The Heath & Hampstead Society

To London Borough of Camden, Tree Preservation Team

Planning Ref: 2020/1757/T (documents from 2020/0306/T)
Address: 9 Willoughby Road NW3 1RT
Case Officer: Tom Little
Date: 12th June 2020

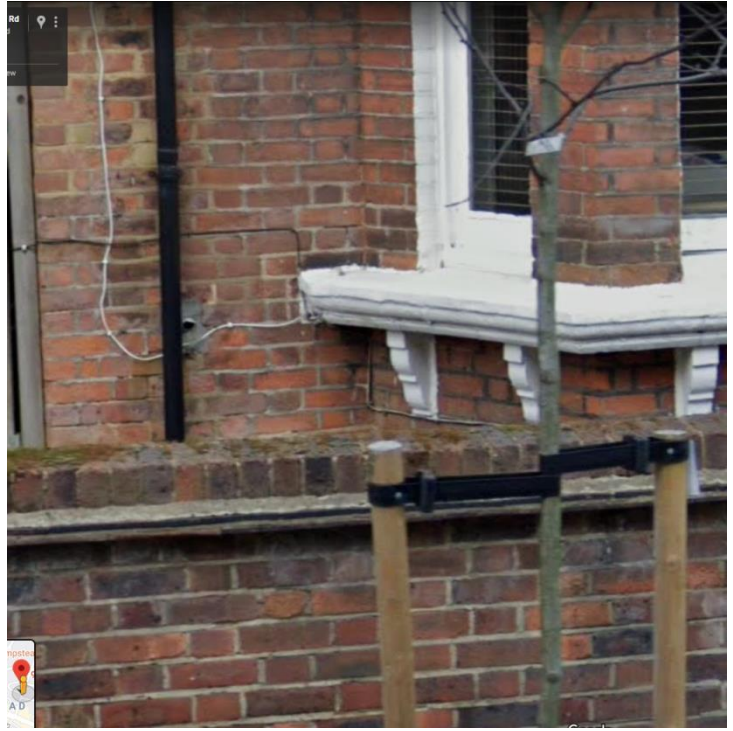
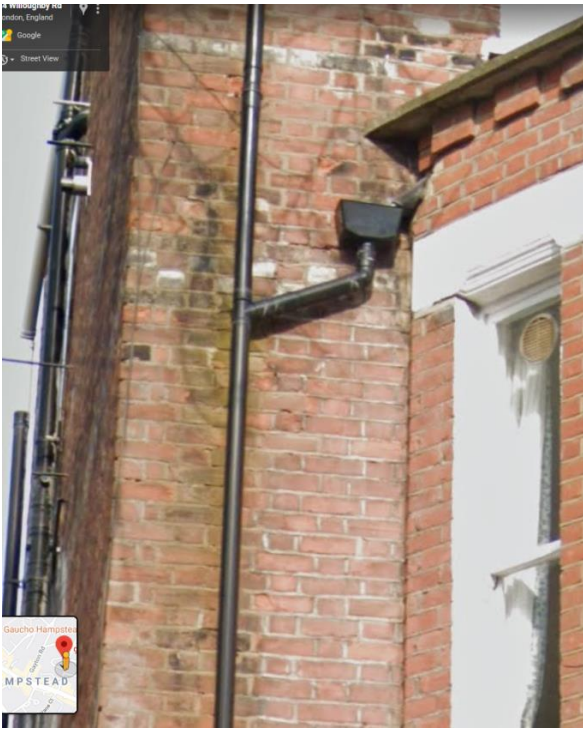
The following photographs show the downpipes and guttering and no doubt the drains themselves remain in an appalling state, indicating that drains surveys should be the first thing to be done, followed by lining all drains with cracks and fixing any failed/broken joints. With silt erosion beneath the drains and other subsidence elsewhere they are bound to have been strained or dropped and leaking. Having fixed these, continuous movement monitoring can then be done, not to then state whatever the outcome "the pattern of movement indicates it's the trees" but to see if this has fixed the movement problem sufficiently - moving it from Grade 3 to 1 or 0 - and to see if further movement can be diagnosed from the patterns of movement in relation to

May 2012 showing many different mortar repairs over the years

April 2019: the outside has been painted, but downpipes are still in a bad way. What state the drains?
